**Re:** Change Order #3 – General Construction Change Orders as Per Attached – Kraus-Anderson Construction Company / NJPA -Gordian eZIQC Contract for Rockridge School

**ROCKRIDGE SCHOOL RENOVATION  
ARI Project # 16-153**

**CHANGE ORDER INFORMATION:**  
Change Order Number: 003  
Date: June 18, 2018

**PROPOSAL REQUEST NUMBER:** 010

DRAWING NAME: EXHIBIT 2.1.A: ADD BITUM. AT EMPLOYEE PARKING

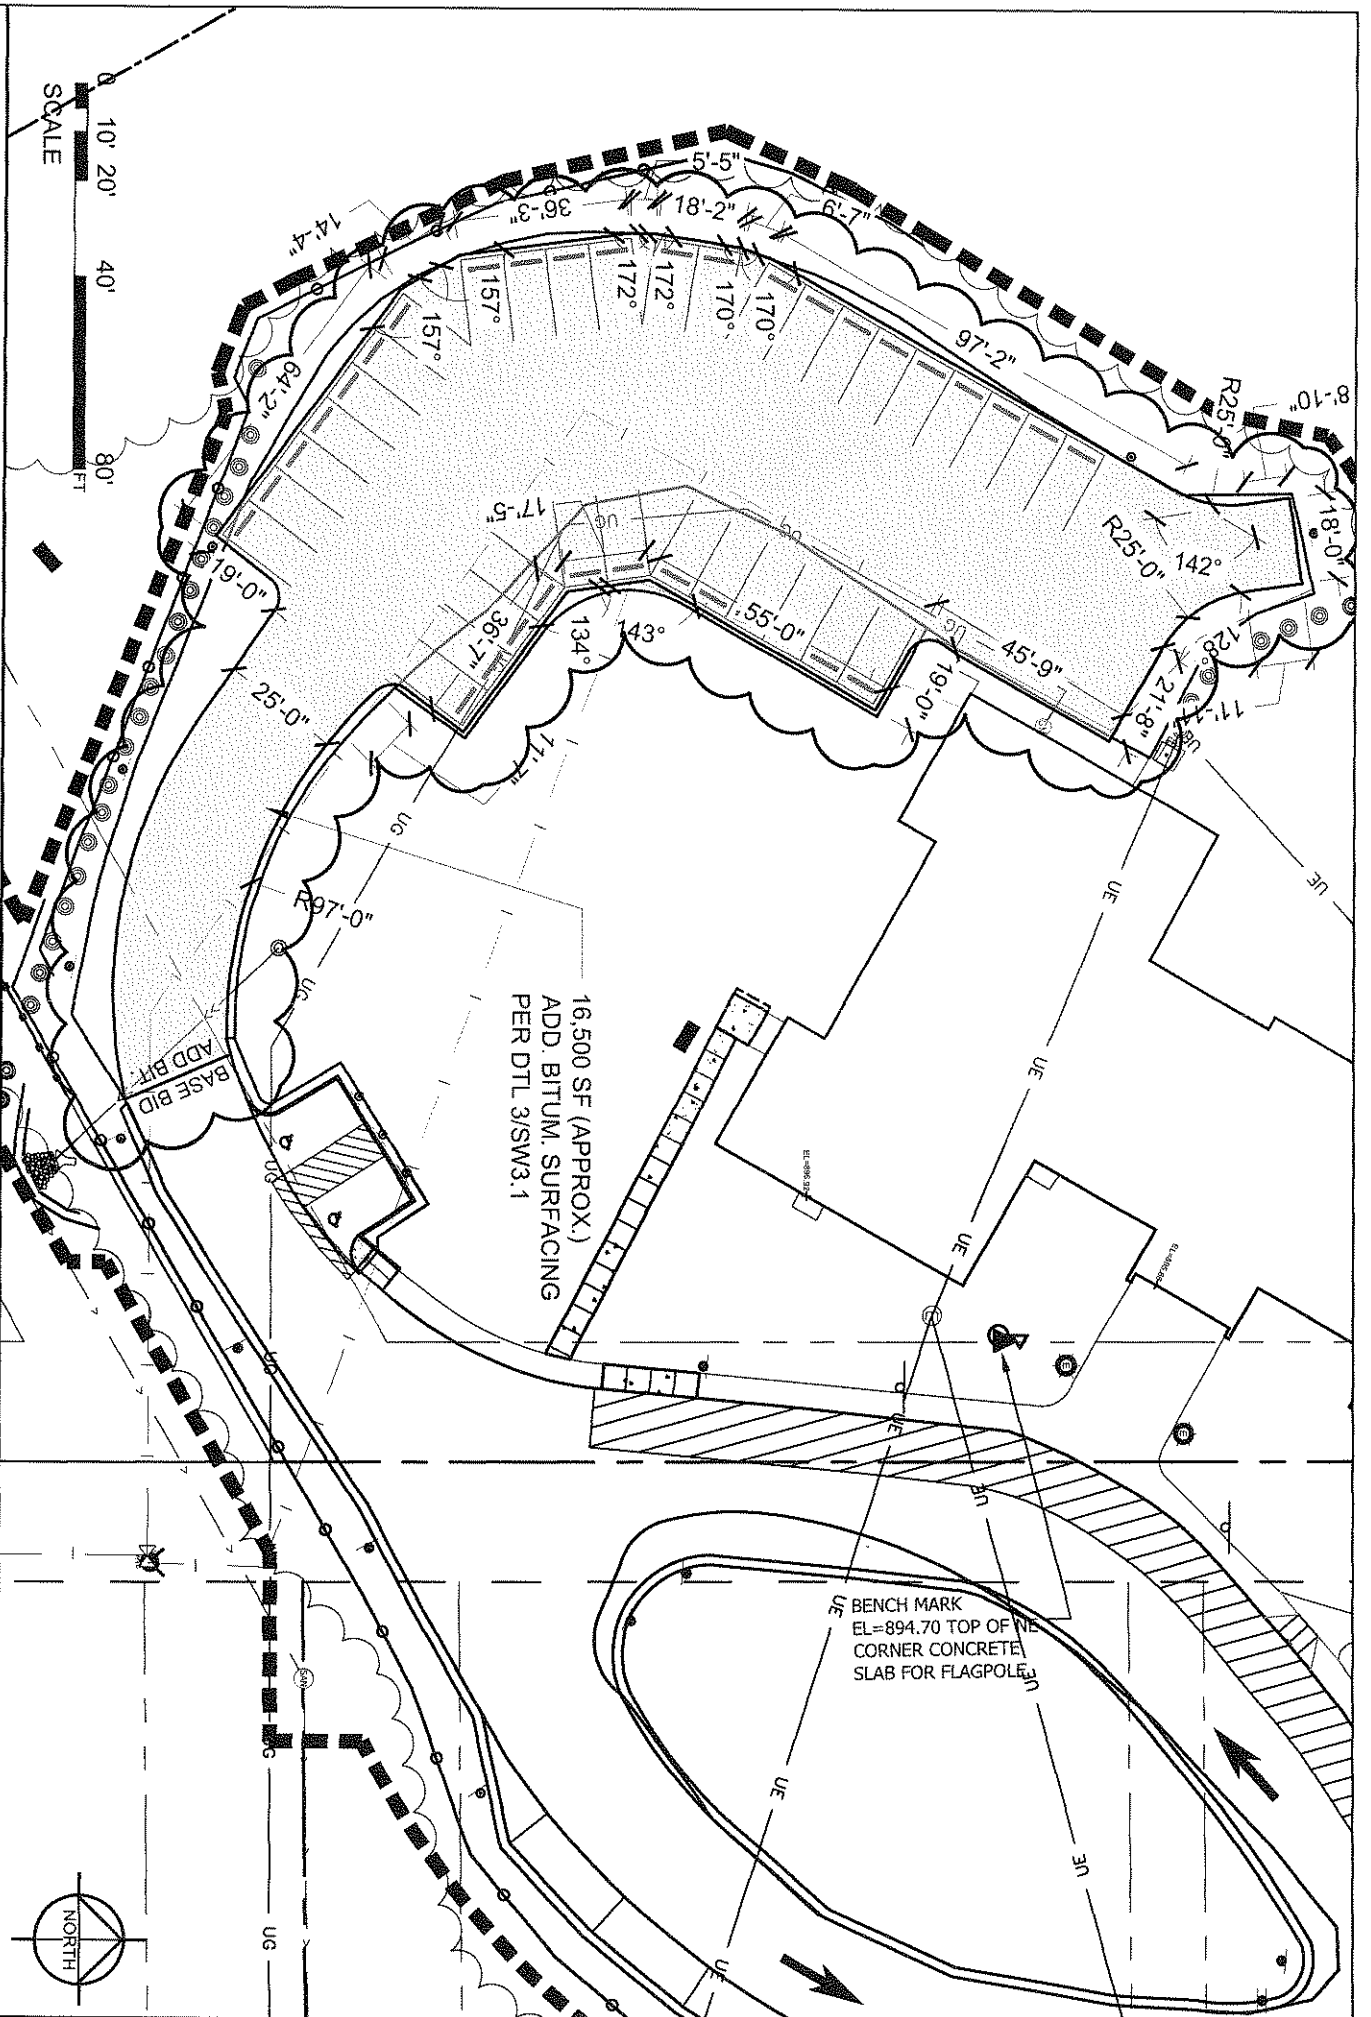
1. Add approximately 16,500 s.f. bituminous paving at existing gravel lot (Exhibit 2.1.A: Add Bitum. at Employee Parking dated 6-4-18).
2. Add 8' x 8' concrete pad at south entry door as shown on attached drawing (Exhibit 2.1.B: Add Conc. Slab at Entry Drive Walk dated 6-4-18).

16,500 SF (APPROX.)  
ADD. BITUM. SURFACING  
PER DTL 3/SW3.1
